A7. POST-APPLICATION DISCUSSION

COMMENTS BY THE PRIMROSE HILL CONSERVATION AREA ADVISORY COMMITTEE

Primrose Hill Primary School Princess Road NW1 8JL Listed Building PRE-APP

A7.2.1 10.05.16. Robert Loader and David Walter met Tanya Skelli-Yaoz and Sarah Freeman at LB Camden to present the proposals. The points arising from the meeting are set out below.

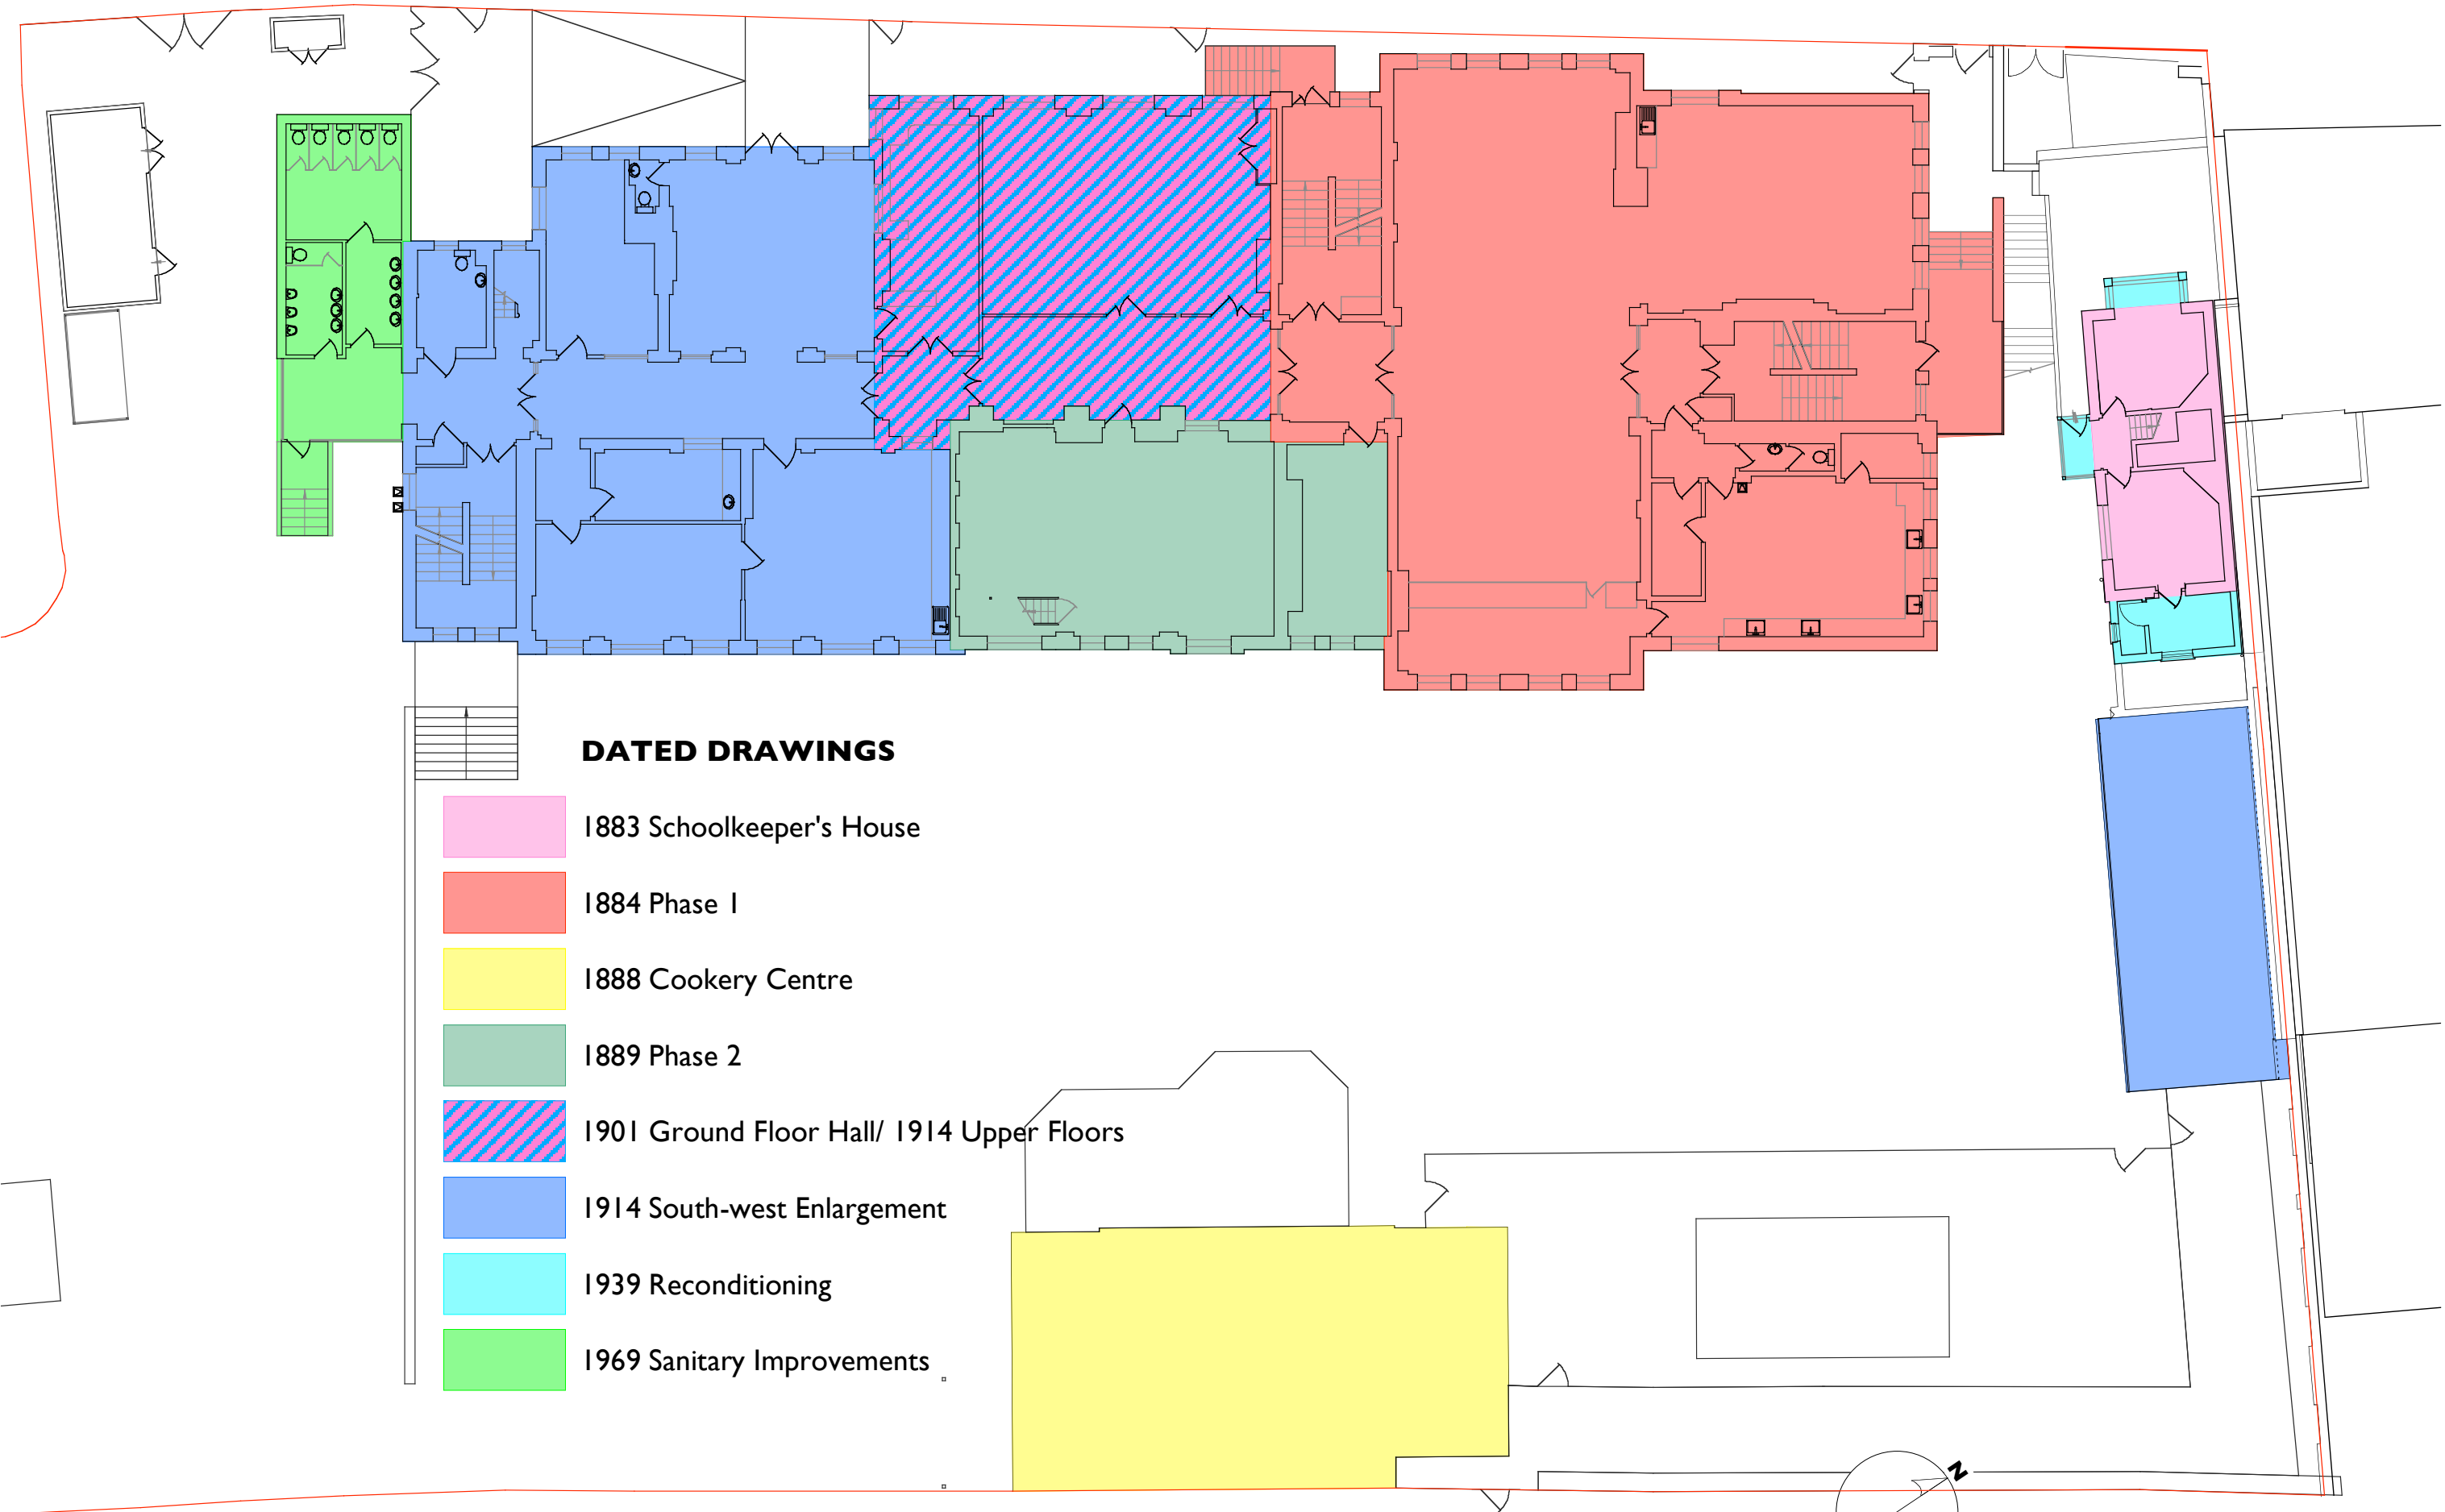
3. Sedum to be considered on roof of Buffer Zone.

4. Glazing to the Canopy would be welcome.

Response: A sedum roof covering is incorporated on the Buffer Zone. Drawing attached below: PRPS PR 112_G.

Response: Glazing to the canopy has been incorporated. Drawings attached below: PRPS PR 112_G, PHPS 200_G and PRPS PR 541_G.

Drawing Title
PLAN - FIRST FLOOR
AS EXISTING

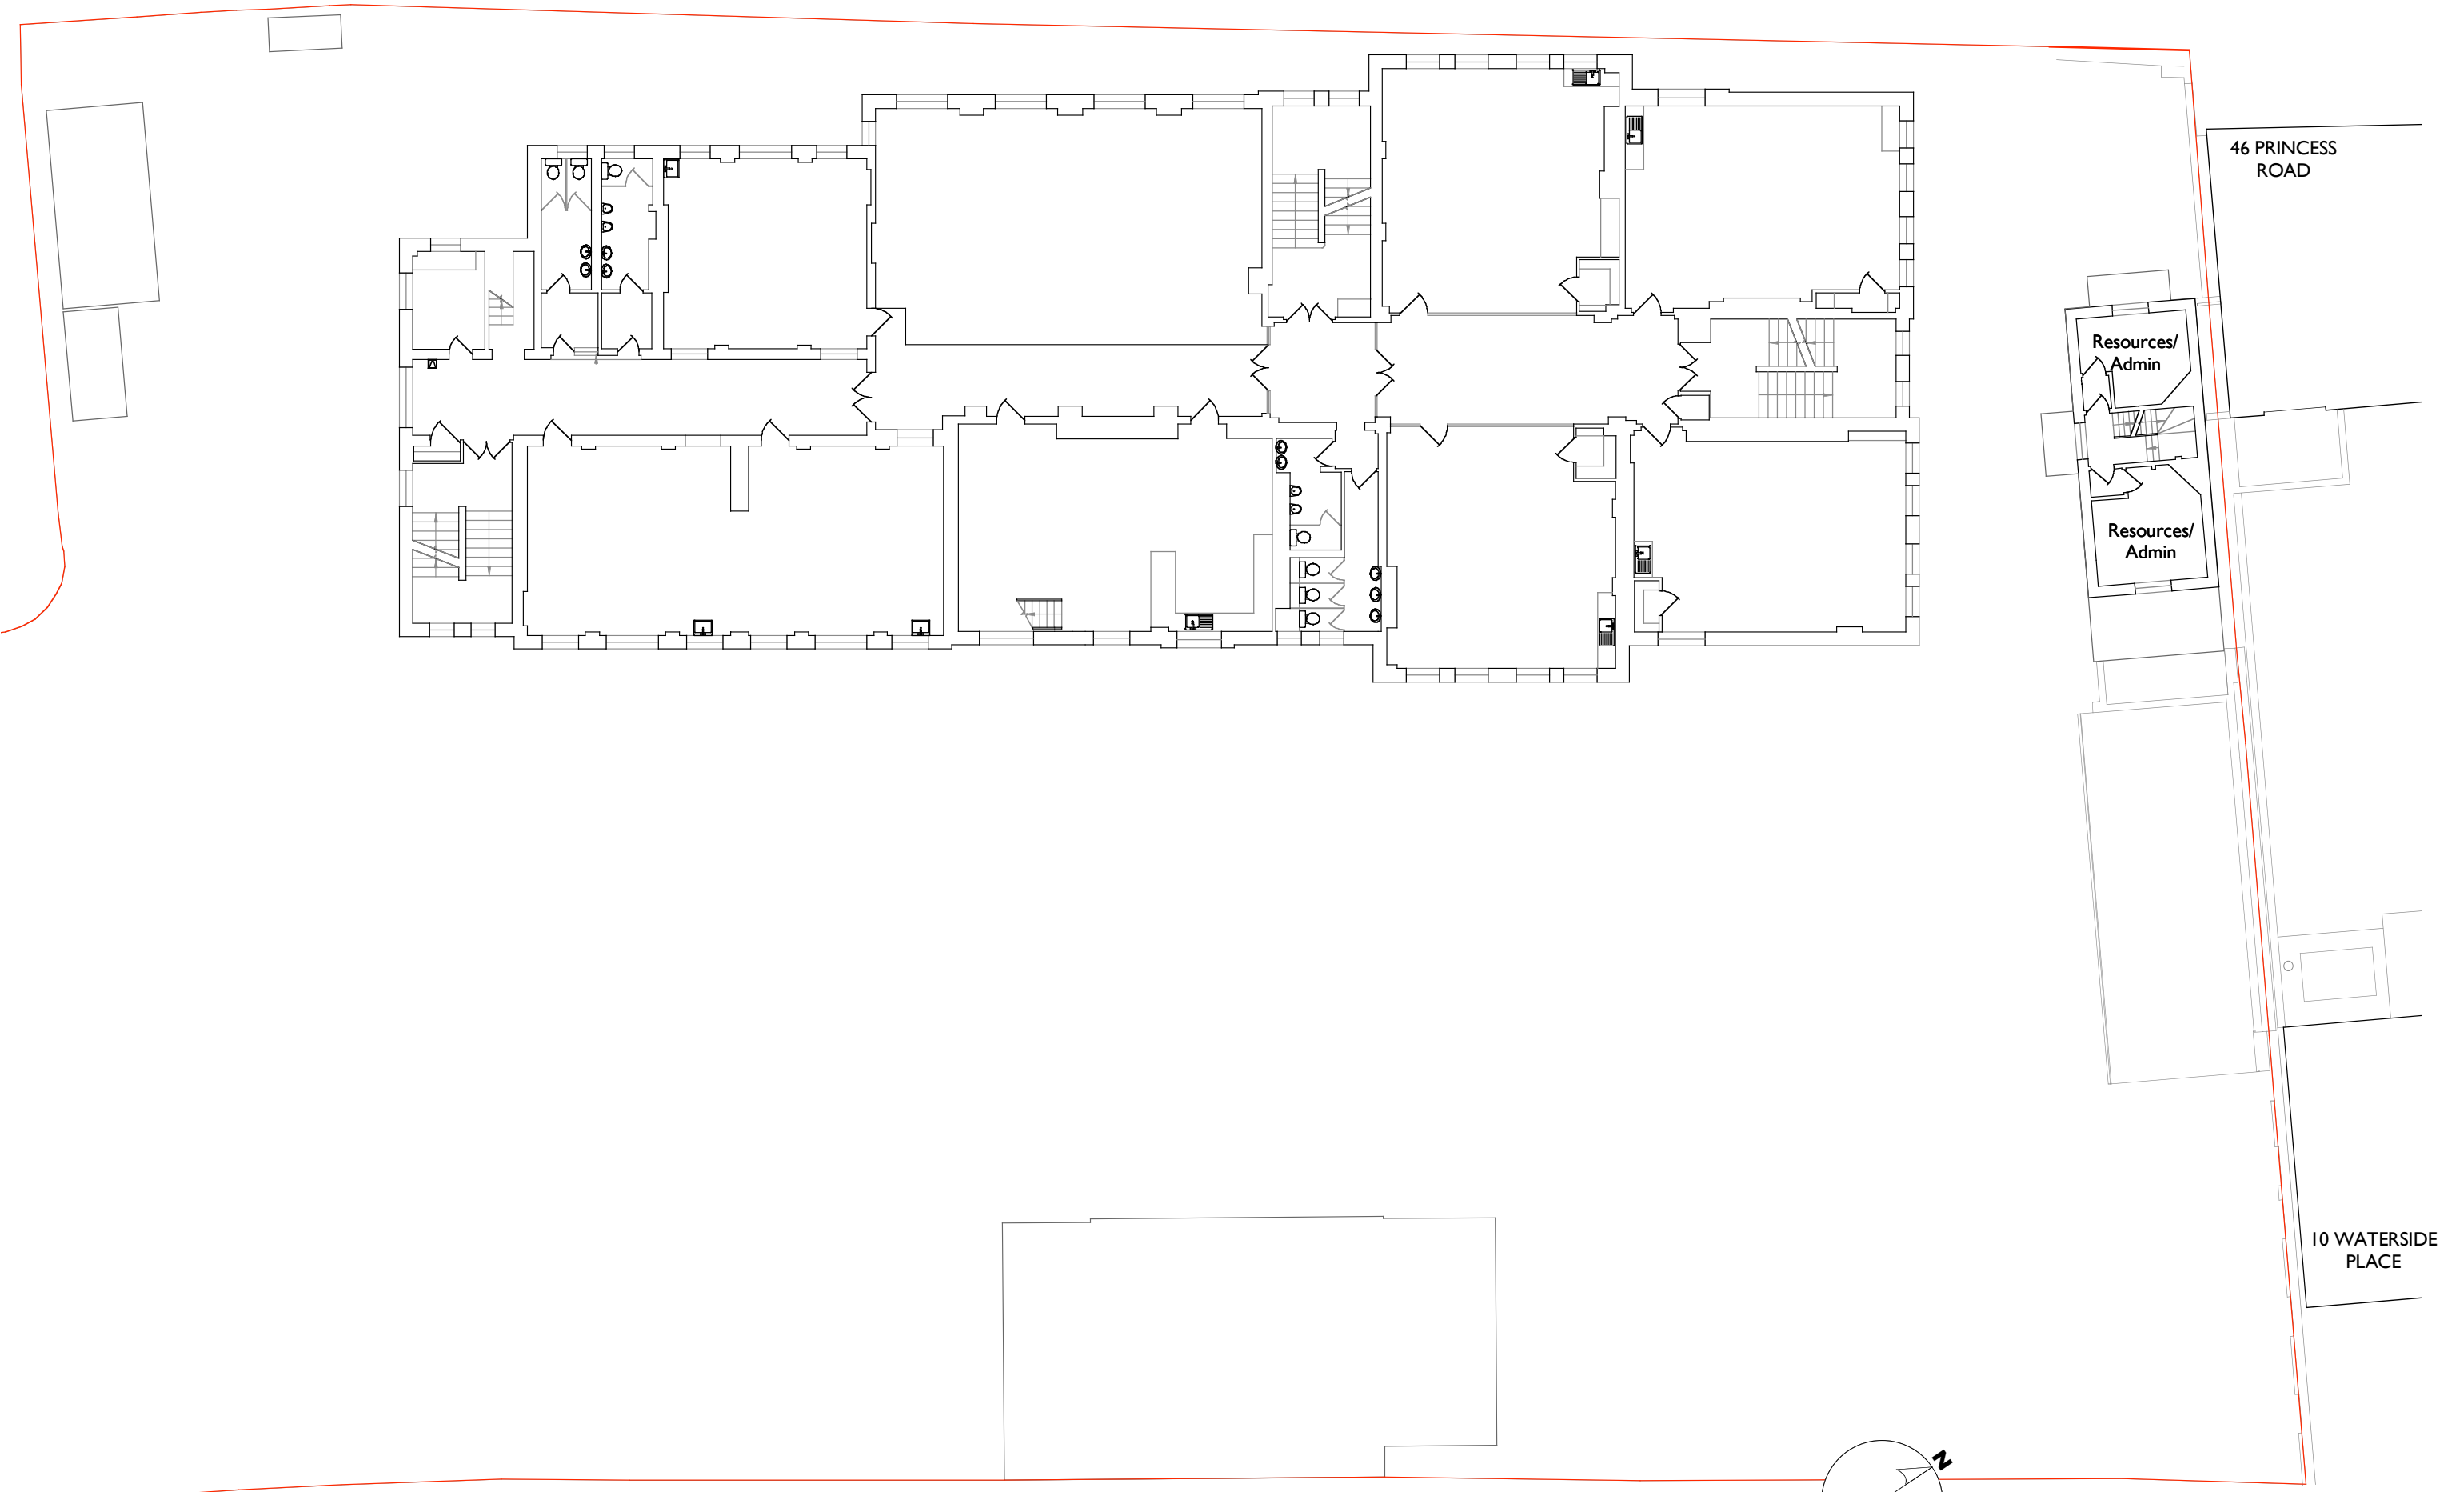
22. Confirmation of proposed numbers of two year-old provision.

There are no proposed changes to the layout or fabric of the first floor. Existing and proposed upper floor plans of the Caretaker's House are attached below: PRPS EX 120_G, PRPS PR 122_G and PRPS EX 130_G.

**NORTH-EAST ELEV
WATERSIDE PLACE**
AS PROPOSED

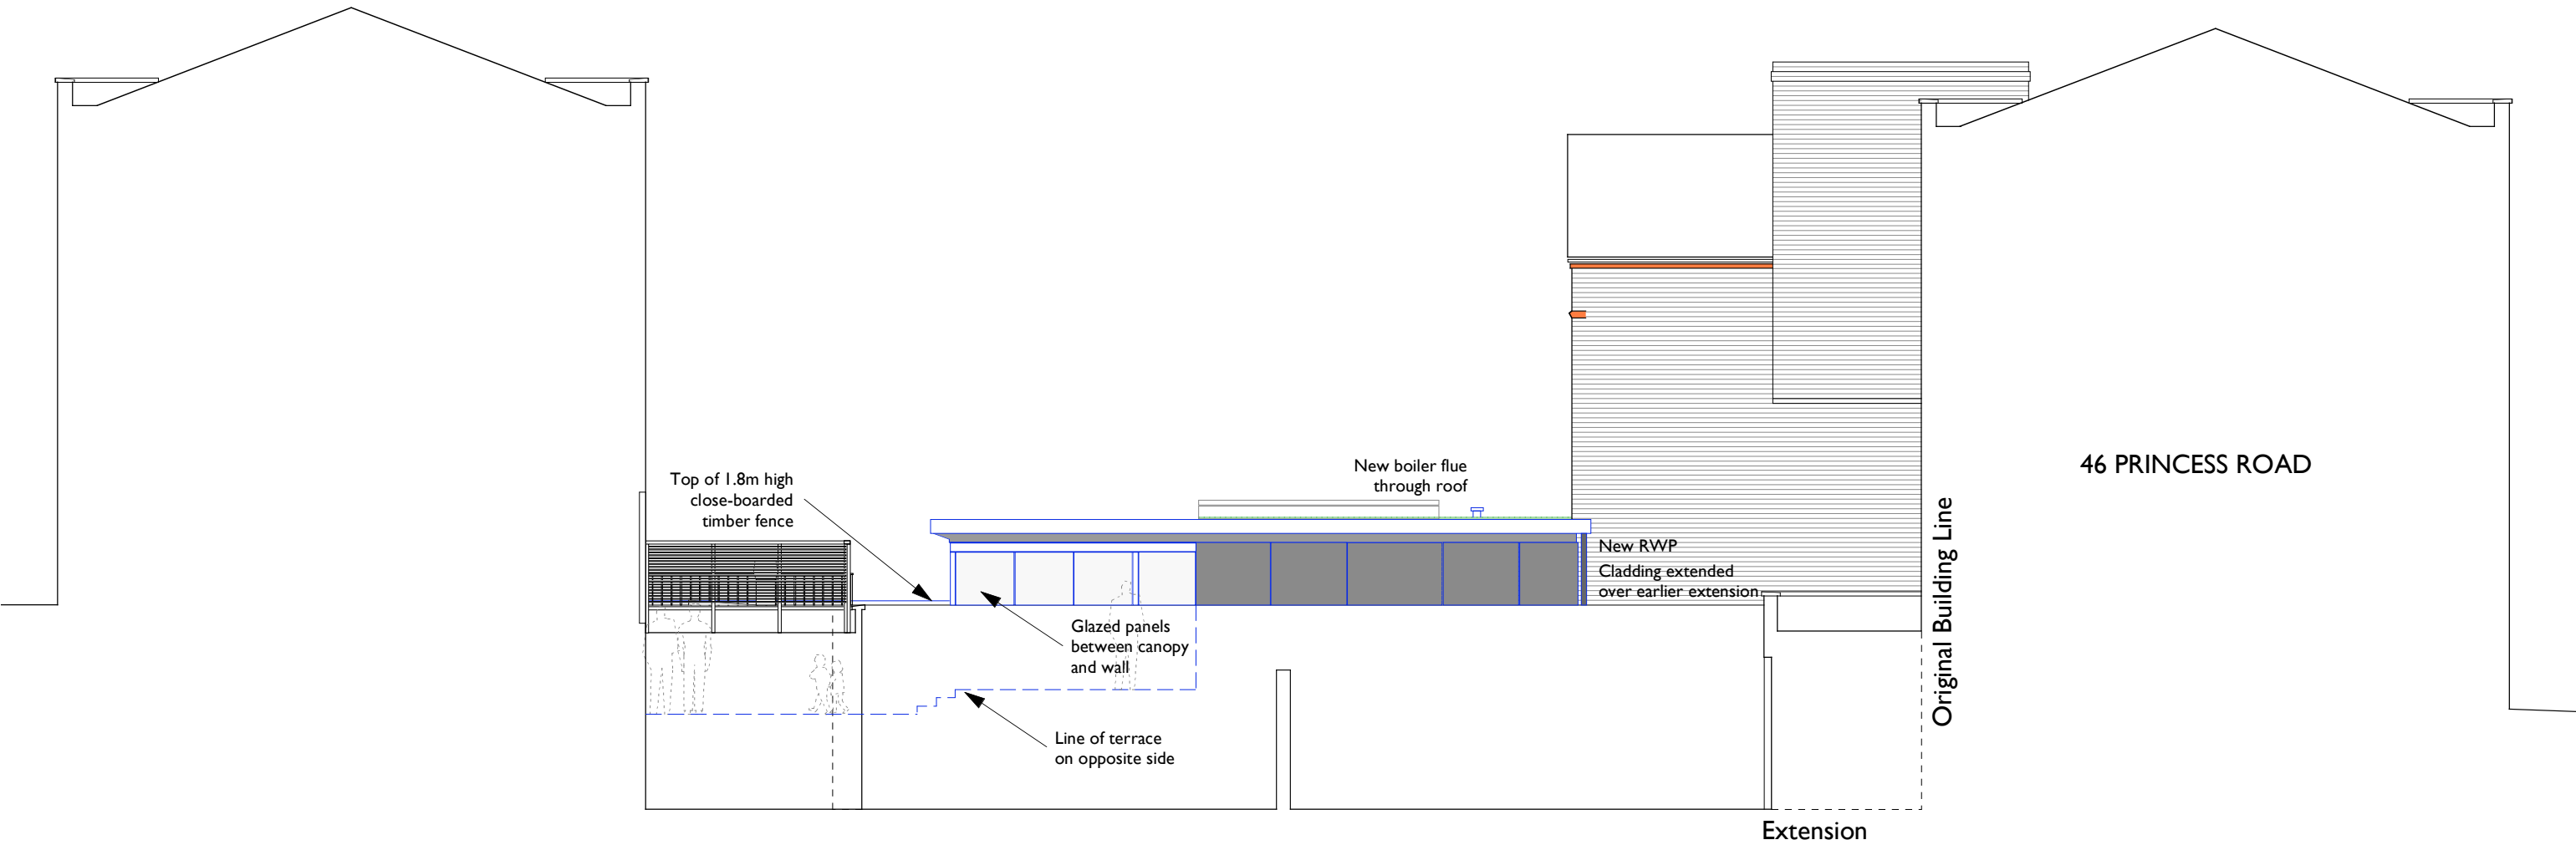
18. Concern about the visual effect of the Eternit cladding to neighbours' side & the messy appearance of an extension on an extension. Consider a green/ living wall.

20. Annotations to drawings to be added and dot-on terrace deck height on neighbours' elevation.

Response: The cladding panels along the boundary to Waterside Place have been extended over the brickwork of the 1939 extension to present a less fussy appearance to Waterside Place. Obscure glazed panels are fitted between the canopy and boundary wall to provide privacy and baffle sound from the upper terrace level.

Response: Annotations to drawings have been added and the terrace deck height is shown dotted on neighbours elevation. Neighbours' boiler boiler flue and terrace enclosure have been added to drawings.
